Bayside Planning Panel

Item No	5.5
Application Type	Development Application
Application Number	DA-2017/105
Lodgement Date	28 September 2016
Property	109-110 The Grand Parade Brighton Le Sands
Owner	Proprietors of SP 1727
Applicant	Mr C Hafouri
Proposal	Integrated Development - Construction of a four (4) storey residential flat building containing 11 apartments, basement car parking, private and communal roof top terrace areas and demolition of existing structures
No. of Submissions	26 letters (Multiple submissions from 8 of 10 objectors i.e. 2 - 5 letters)
Cost of Development	\$5,302,943
Report by	Fiona Prodromou – Senior Assessment Planner

Planning Assessment Report

Application Number:	DA-2017/105
Date of Receipt:	28 September 2016
Property:	109 - 110 The Grand Parade, BRIGHTON LE SANDS (SP 1727)
Owner:	The Prop Of Strata Plan 1727
Applicant:	Mr Carlos Hafouri
Proposal:	Integrated Development - Construction of a four (4) storey residential flat building containing 11 apartments, basement car parking, private and communal roof top terrace areas and demolition of existing structures
Recommendation:	Refused
No. of submissions:	26 letters (Multiple submissions from 8 of 10 objector

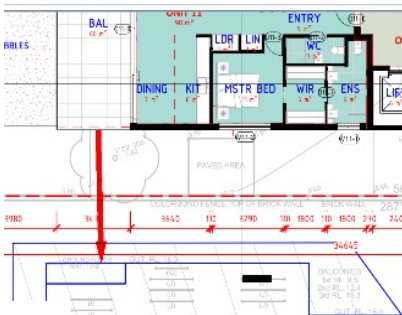
An existing two storey flat building is positioned upon 106 The Grand Parade. A full height glazed dining room window is proposed to unit 7 at level 1 on the northern façade, 5.4m directly opposite 1 x south facing kitchen window to a unit within this adjoining building. This results in the direct overlooking of this neighbour.

Overlooking at level 3

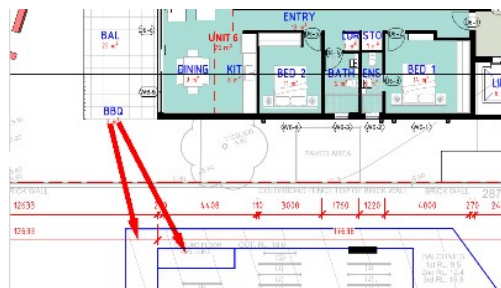
Plans illustrate the provision of rear facing balconies to proposed units 6/9/11 at levels 1/2 and 3 on site. Balconies to these units are not provided with appropriate privacy screening to the southern side and given the reduced separation i.e. 5.165m balcony to balcony in this instance, adverse privacy impacts arise to the habitable windows and private open space areas of the 3 units within the rear of the southern adjoining block at 112 The Grand Parade. This is unsatisfactory.
